**Re: Implementation of the Alternative Energy Portfolio Standards Act of 2004:  
Standards for the Participation of Demand Side Management Resources –  
Technical Reference Manual 2011 Update – Docket No. M-00051865**

**COMMENTS OF PECO ENERGY COMPANY ON THE  
PROPOSED UPDATE TO THE TECHNICAL REFERENCE MANUAL**

**APPENDIX A**

**Figure 1 Comparison of CFL Markets.**

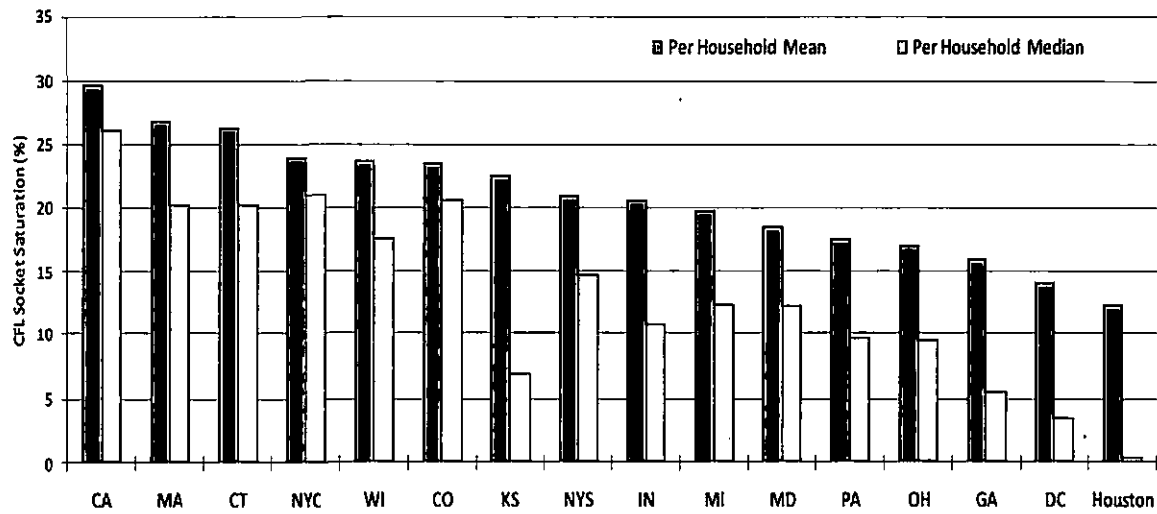
The median CFL saturation in California households is 2.5 times higher than in Pennsylvania. *See* Figure 1. As CFLs become more commonplace, and their use more widespread, they tend to have lower HOU, on average, because the initial CFL bulb installations are in the most favorable locations in terms of bulb usage and payback. Homeowners will first look to displace inefficient incandescent bulbs in high usage locations such as kitchens, dining rooms, living rooms and outside. Later on, as they gain more experience and become comfortable with the CFL color rendition and light quality, homeowners install CFLs in lower-use locations, such as bathrooms and bedrooms. California has, in fact, experienced a significant decline in average HOU in only the past few years. *See* Table 1.
